CITY OF HOUSTON

SUBJECT: **Letter of Clarification No. 4**

REFERENCE: Request for Competitive Sealed Proposal (CSP) Rehabilitation of Taxiways SA & SB at George Bush Intercontinental Airport; Solicitation No. HJA-TXSASB-2023-022; Project No. 646A

1 C07.31 TYPICAL MAINT RAMP AND LANDING DETAIL
SCALE: NTS

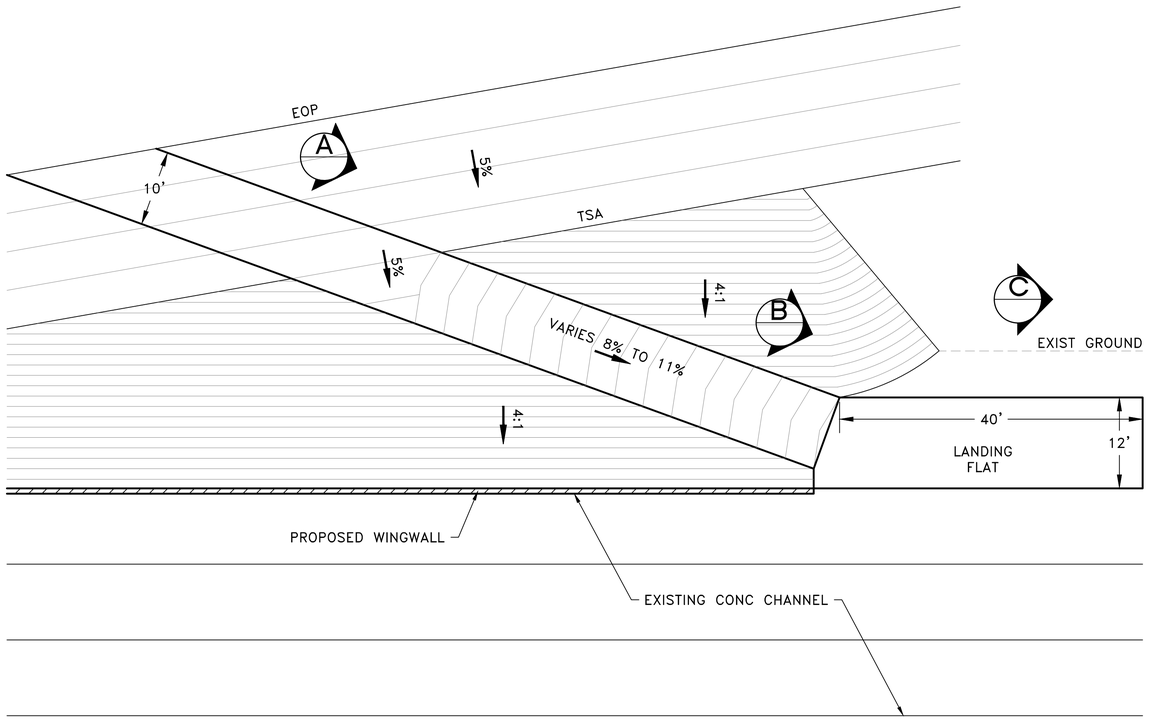
57. **Question:** Referencing sheet C07.31 calls for 6" Cement Stabilized Sand beneath all slope paving. Where is the placement of this material to be paid for?

58. **Question:** Referencing sheet C07.31 calls for rebar #4 bars on 12" centers. Would a 6 x 6 Welded Wire Mesh be an acceptable alternative for the slope paving?

PROJECT NO.	0646A
A.I.P. NO.	XXXX
C.I.P. NO.	A-0515
H.A.S. NO.	20C0646A
SHEET NO.	C10.02

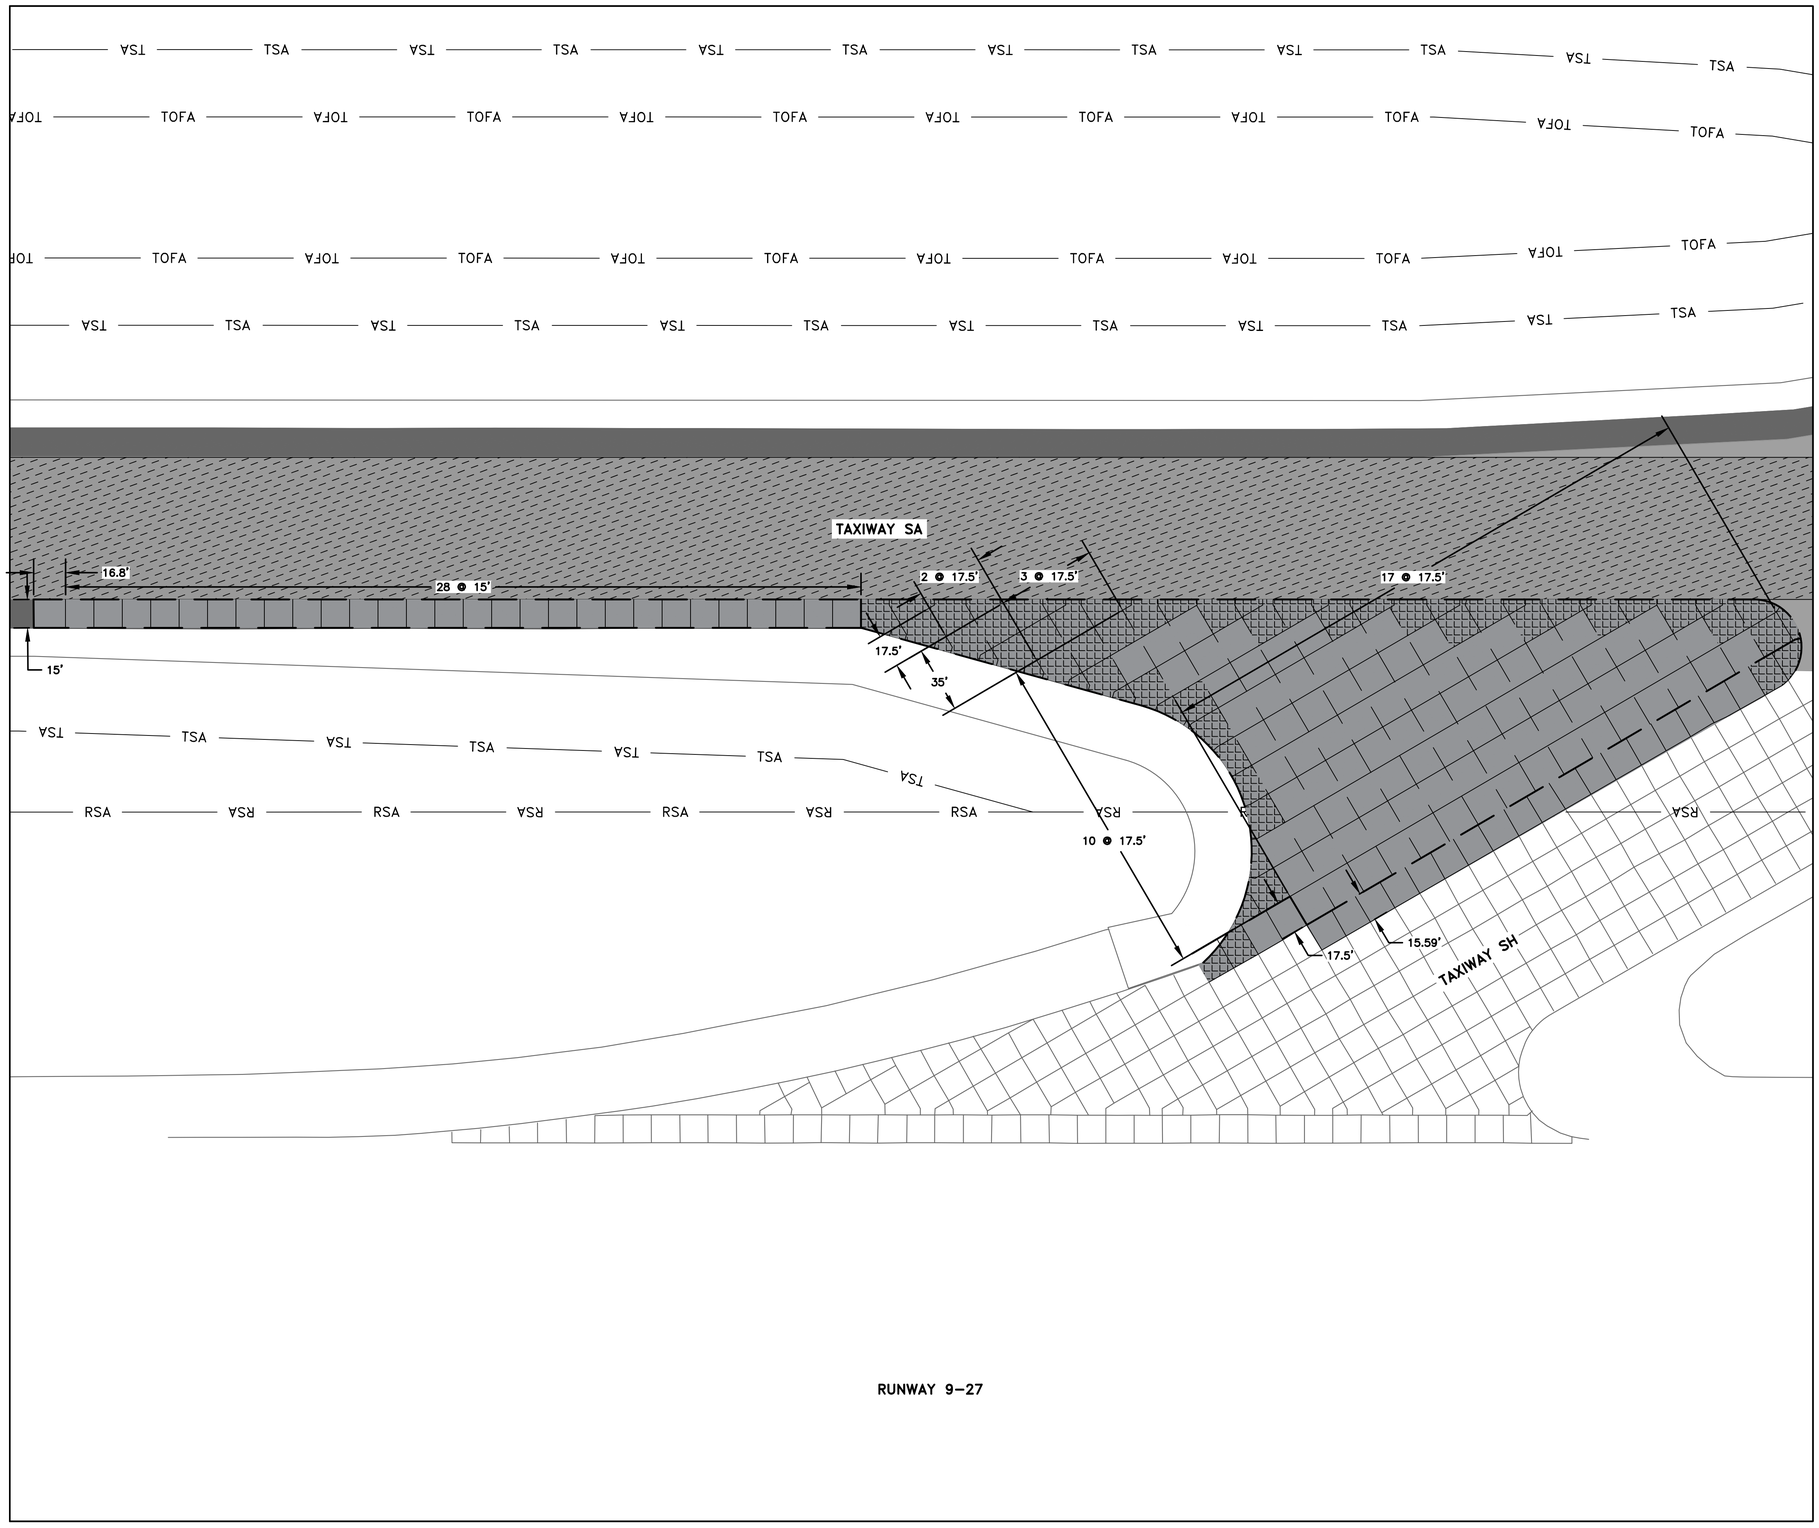
49. **Question:** Please confirm the scaling on C10.02. When using takeoff software's and applying the scale in the upper right-hand corner, the defined lengths on the joint layout do not match. The panels are called out as a 17.5' width but being scaled they show more like 12.5' wide?

Response: The scaling on sheet C10.02 is," = 40'. The sheet has been updated (Attached).

2 E04.02 BASE MOUNTED IN–PAVEMENT LIGHT – PAVEMENT OVERLAY

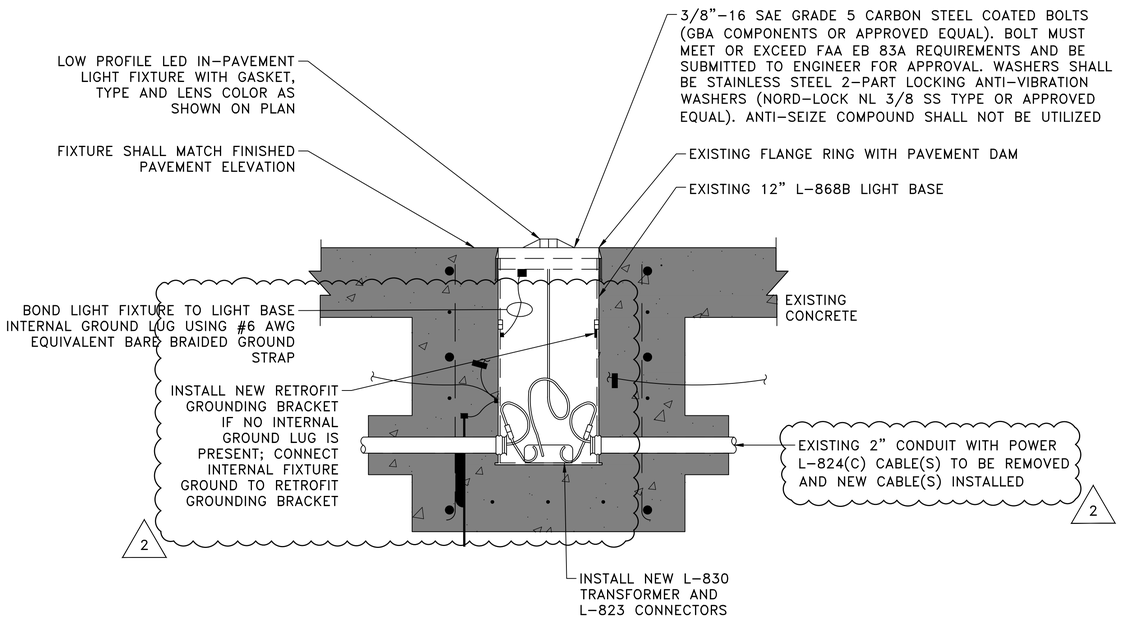
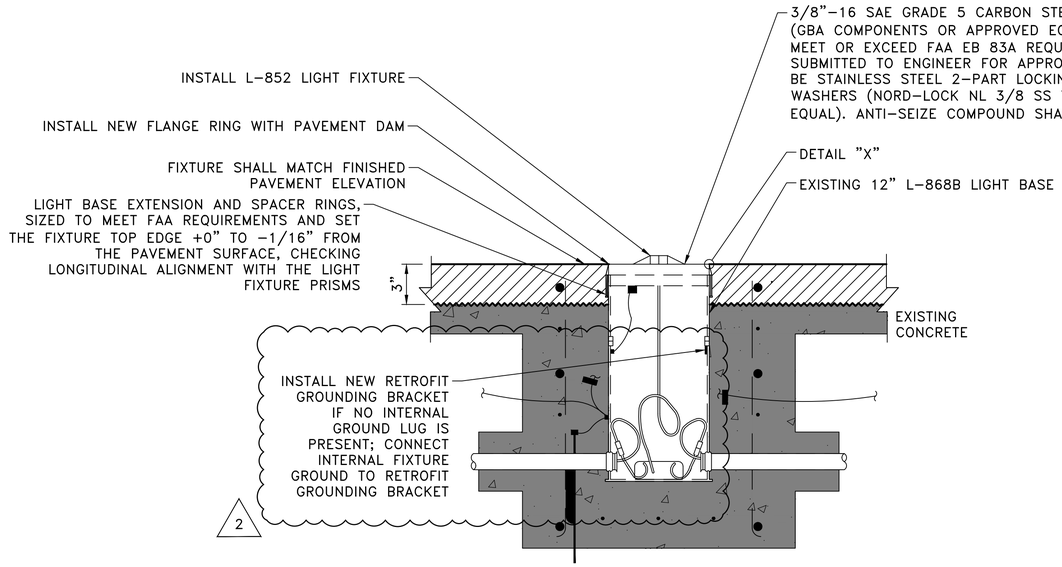
69. **Question:** Sheet E04.02 Note 9, states "Maximum of (3) three rings may be stacked together to bring the light fixtures to the correct elevation." Our record shows more than one extension on existing centerline Base Cans. Do we have to remove all the extension(S) from the bottom sections or Base Cans? If your answer is no, how are going to meet the three ring requirements? Example: adding just a flange ring and a pair of dial a bevel ring will meet the three rings max but we still must add spacer(s) for height adjustments at the new asphalt. - Can a Bid Line Item be added for Top Sections? Can Bid Line Items be added for Spacer Rings.

70. **Question:** Sheet E04.02 Detail 2 shows Multi-Adapter Ring. Are you referring to HAS Standard Top Section with Multi-Hole Adapter Ring for existing and new Base Cans?

71. **Question:** Sheet E04.02, detail 3 calls to abandon existing cable in place. This cable must be intercepted at the nearest pull box and respliced to complete the circuit. Please clarify?

72. **Question:** Sheet E04.02 if the Existing Base Cans does not have grounding lug. Can you provide a detail to ground to the existing Base Cans? Can a Bid Line Item be added for a retrofit ground lug on existing base can?

Response: Yes, additional notes have been added to the details on sheet E04.02 detailing the process of installing a retrofit grounding bracket. A bid item has been added to cover this work.

PROJECT NO.	0646A
A.I.P. NO.	XXXX
C.I.P. NO.	A-0515
H.A.S. NO.	20C0646A
SHEET NO.	E04.03

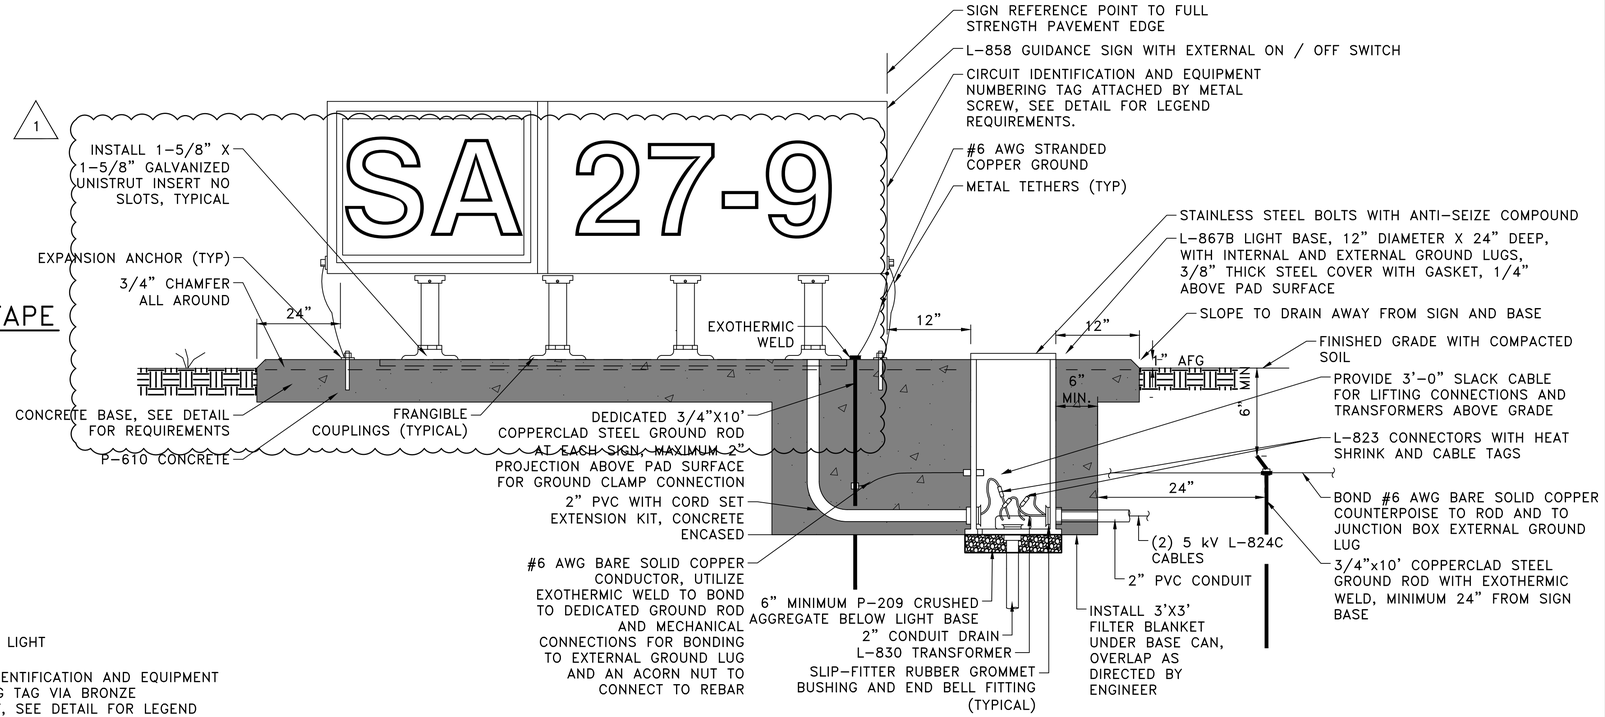
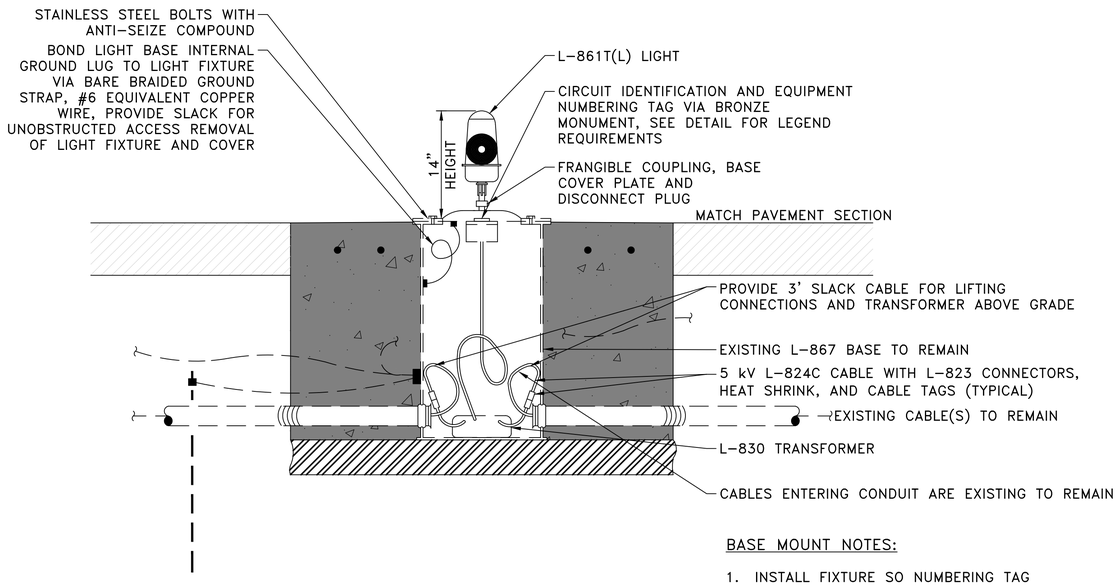
73. **Question:** Sheet E04.03 detail 3 Base mounted sign. Note 13 states "All new signs shall be installed and bolted to a Unistrut 1 5/8" x 1 5/8" galvanized". Sign detail calls for Stainless Steel Expansion bolts. Which type of anchoring will be required? Provide Expansion bolts size if this will be required.?

Response: Detail 3/sheet E04.03 has been revised in this Letter of Clarification #4 to remove the stainless-steel expansion bolts and show the channel strut anchored to the concrete pad and the sign leg flanges anchored to the channel strut.

1 E04.05 PREFABRICATED CONCRETE HANDHOLE

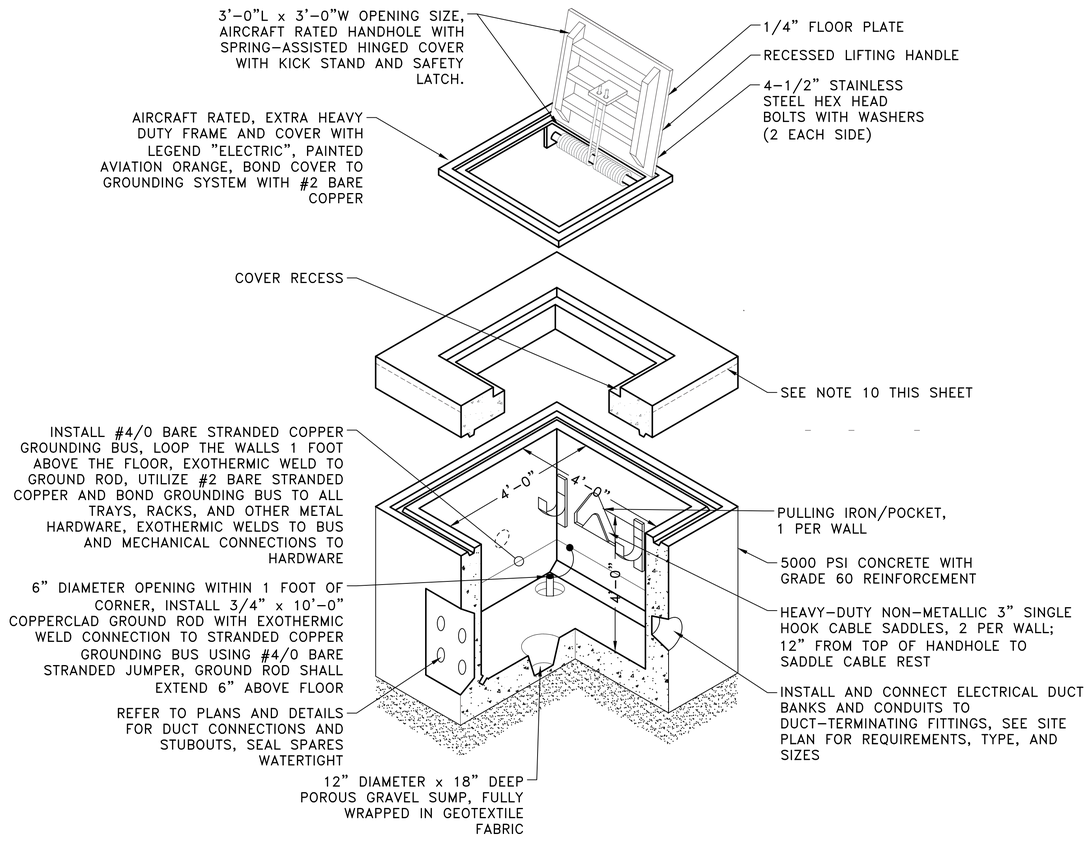
74. **Question:** Sheet E04.05 Detail 2 states “Adjustment height 3” minimum. Contractor shall verify in the field the proper adjustment of each light prior to any work. If the adjustment require lesser height, are we still to install the minimum height of 3”?

Response: The Contractor shall provide shop drawings for the adjustment of each junction structure type encountered in the project area per note added to detail 2/sheet E04.05.
